TECHNICAL BULLETIN

MODEL/DERIVATIVE:
Freelander

Bulletin N°: 0029
CDS. ref: L8618bu
Issue: 1
Date: 27.09.2000

PROBLEM:
HILL DESCENT CONTROL (HDC) WARNING LIGHT ILLUMINATED - THROTTLE CABLE
The customer complains that the amber HDC warning light is illuminating.

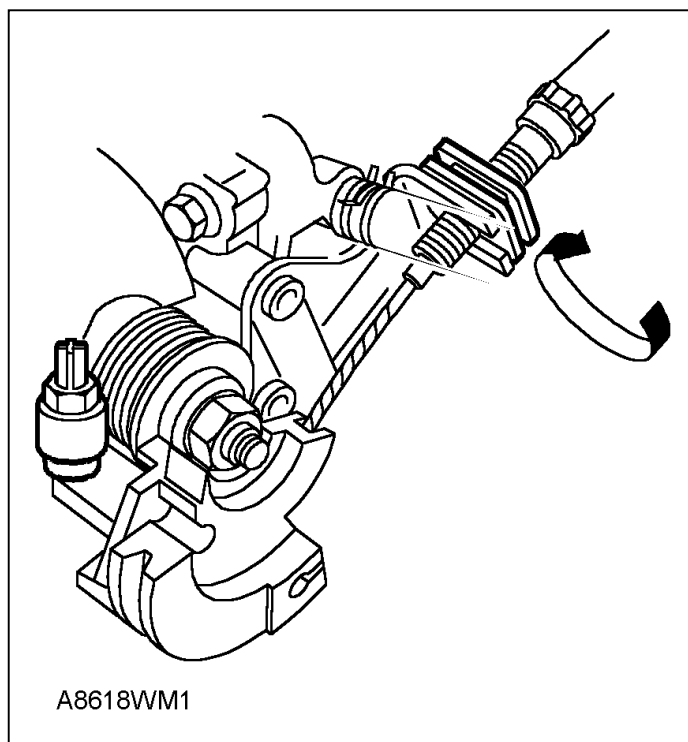
CAUSE:
Insufficient free play in throttle cable.

Upon customer complaint of the amber HDC light on, or when carrying out any throttle cable related repair, refer to the procedure below to ensure correct setting of the throttle cable free play.

- Refer to Workshop Manual repair number [19.20.05](#), K1.8 or KV6 section as appropriate, for the adjustment procedure.
- On completion, check free play at the accelerator pedal pad. A free play of $12 \pm 1\text{mm}$ is required. If necessary, readjust the cable until this is achieved.
- Should the warning light remain illuminated after the ignition has been turned off and on, use TestBook to remove any fault codes stored in the ECU and to extinguish the warning light.
